Notice of switch parts in AC brake coil for 380V class and 400V class

| Subject | Notice of switch parts in AC brake coil for 380V class and 400V class | Date of issue | January 20, 2021 |

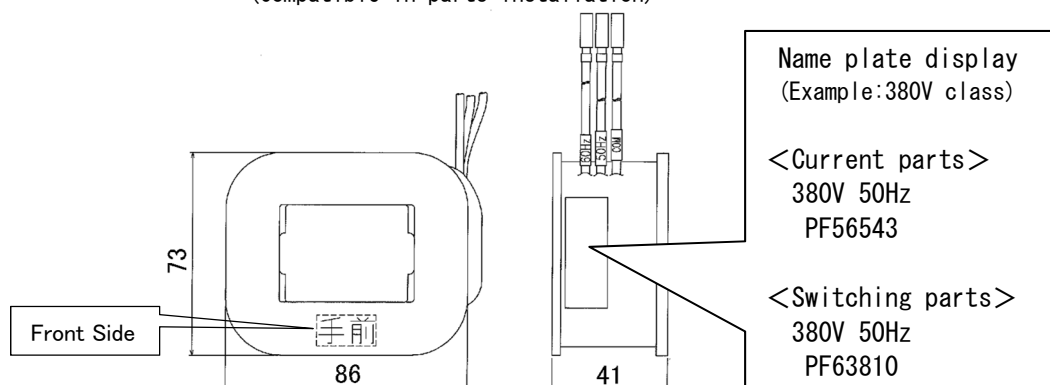
For quality improvement purpose, AC brake coil for 380V and 400V class will be switched accordingly. (200V class previously announced No.855-0308)

4. Appearance comparison: There is no change in appearance other than outline indication number.

(Compatible in parts installation)

| Rated voltage | 380V | | 400V | | 400V (440V) | |
|-------------------------|------------|------------|------------|------------|-------------|------------|
| Outline | PF56543G01 | PF63810G01 | PF58144G01 | PF63334G01 | PF58144G01 | PF63334G01 |
| Resistance value (20°C) | 23.0Ω | 22.0Ω | 28.4Ω | 27.9Ω | 23.1Ω | 23.6Ω |
